CELIER AVIATION	Bulletin Service Letter Level:MANDATORY	Aircraft Type: Xenon R/RT/RST
----------------------------	--	--

This bulletin service mandatory concerns all Xenon with a black V top control horn with the cube having rounded edges. It does NOT concern older versions with the sharp edges..

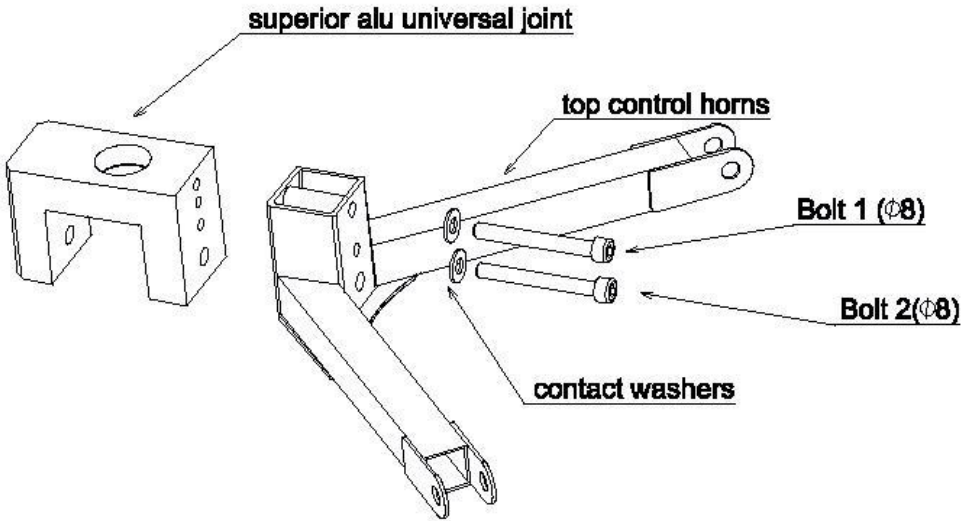
As a preventive action, we want to add a security in the fixation of that part, with a third screw. Also replacing the older one with the new model that will penetrate with its smooth section in the hole, thus the force is exercised correctly, not on the tread.
New special bolts are provided by our factory. Please send your address complete for shipping.

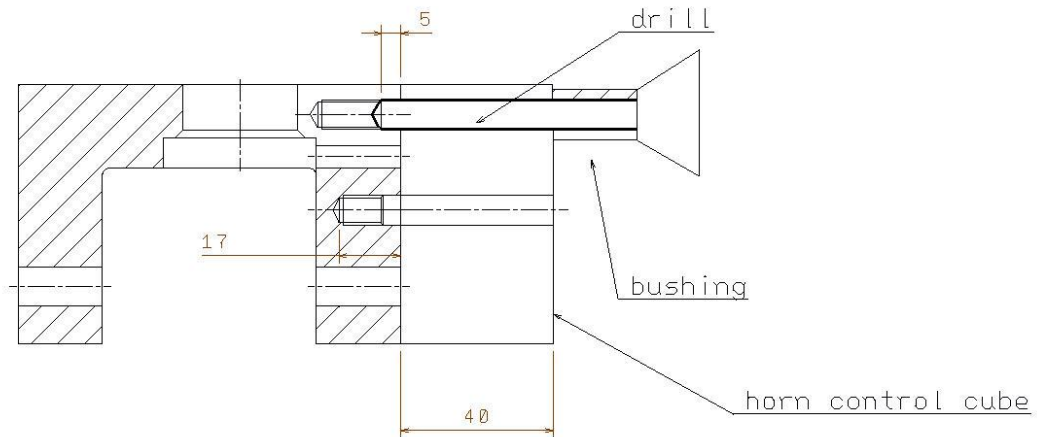
1. Remove the old Ø8 bolt.
2. Drill through M8 as it is shown on the drawing. Adjust length of the drill, so that the bushing stops it after 5mm of drilling (bushing must limit the length of the drill to 45 mm)

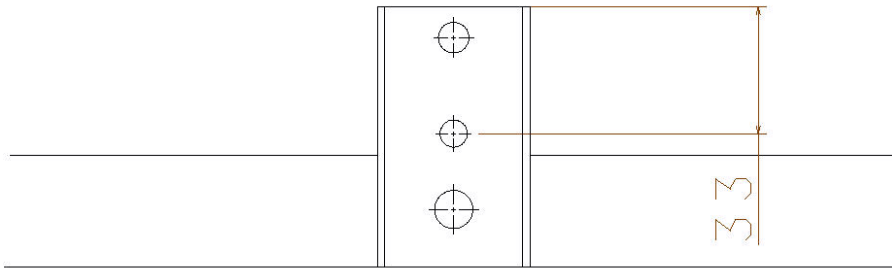
3. Make a new Ø6.5 hole in horn control cube as it's shown on the drawing

4. Fix control horn back and use Ø6.5 hole as a guidance to drill in alu universal joint a hole 17 mm depth.
5. Remove the control horn and make M8 thread in alu universal joint Ø6.5 hole.
6. Fix the control horn back and repeat the same operation in this new hole as (2)
7. Remove again control horn to clean with compressed air both holes.
8. Fix control horn back via 3 points. Put blue Loctite (Medium) on the threads of the 2 upper bolts ó fix ó torque to 25Nm.
9. Install safety wire through holes of both upper bolts
10. Medium tight the roll axle Ø10 nut, until limit of free movement (roll) of the head (it must not force). Place back the safety pin.
